ADDENDUM No. 1

Skagit County Public Works

**Request for Proposals for the
Selection of the Electrical Systems Integrator For
Guemes Island Ferry Replacement Project #ESMVGUE-1**

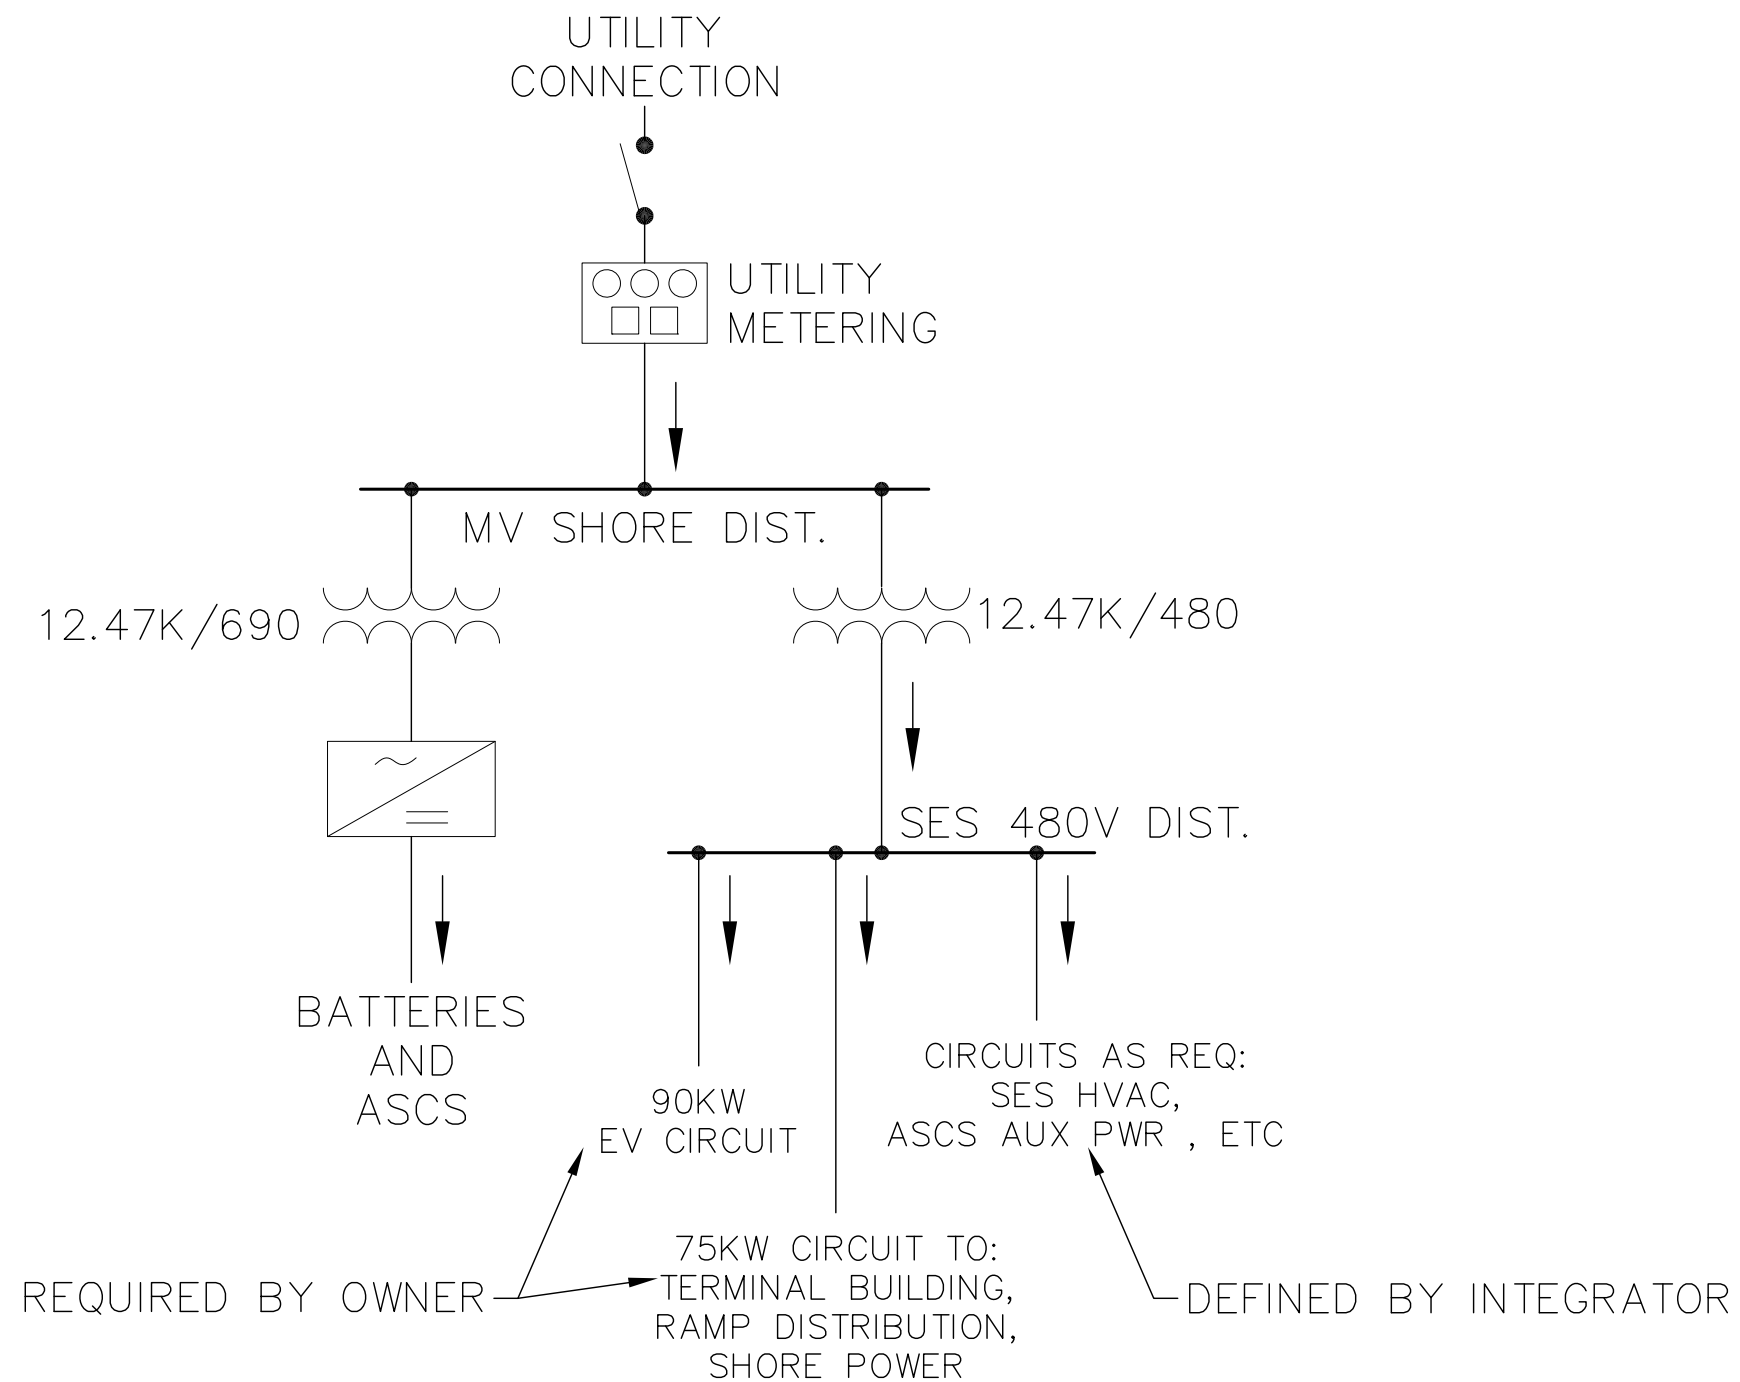
16	SES Clarifications from Glosten	On further review, the main transformer rating in the RFP is too high and the RFP does not clearly reflect the SES design flexibility available to integrators. Some notes: • Estimated load for the terminal building and ramp supply (Table 5) is revised from 200kw down to 75kw • There may be one or more main transformers, per integrator discretion. The attached sketch shows two possible arrangements. Other arrangements that meet the functional requirements are also acceptable. • The integrator is responsible for sizing transformers, considering arrangement, loads, power factor, and harmonic distortion. kw ratings provided in the RFP and this addendum are nominal • Attention is drawn to lines 426-435, which give updates to the one-line diagram: the existing terminal distribution will be supplied from the new SES. ASCS aux power will not be taken from existing terminal distribution • RFP Section 003.5 is titled "AC Terminal Distribution" and gives requirements for SES 480V distribution. It includes some descriptive details of infrastructure <u>downstream of the SES that will not be modified by the integrator</u> • 17097.02-300-02, Electrical One Line, shows the 480V "AC Terminal Distribution" swbd in the SES directly feeding the ramp distribution. A single SES circuit will supply existing distribution for the terminal building, ramp, and 480V ferry shore power.

17	Clarify transformer size requirements: • The size of the 3S and 2S supply from grid-converters are not shown on one-line diagram • The 3S/1S transformer is listed as 100kVA, but should be 125kVA based on 150A/480V supply breaker	75kVA of load should be utilized to size the transformers and grid converters. This supersedes the sizes listed in the single line diagram and applies to the 3S and 2S grid converters and transformers, and to the 3S/1S transformer. As noted above in #16, integrators are responsible to increase sizing if required due to harmonic distortion. This sizing is based on preliminary estimates of auxiliary loads; these will be finalized during contract design and sizing modified if necessary.
18	The one-line diagram shows "propulsion auxiliaries" load connected to DC busses with a cloud (TBD with vendor). • Is there any particular description of what type of load here and what load size kVA? • Should we propose VFD's for these loads?	If desired, you may propose to relocate loads such as steering motors, cooling pumps, etc to be supplied by VFD directly from the DC bus. Include VFDs in your scope and commercial quote if this approach is utilized.

1. TWO ACCEPTABLE LAYOUTS ARE SHOWN. OTHERS ARE POSSIBLE.
2. 690V IS TYPICAL BUT NOT REQUIRED.
3. ALL TRANSFORMERS ARE IN THE INTEGRATOR'S SCOPE
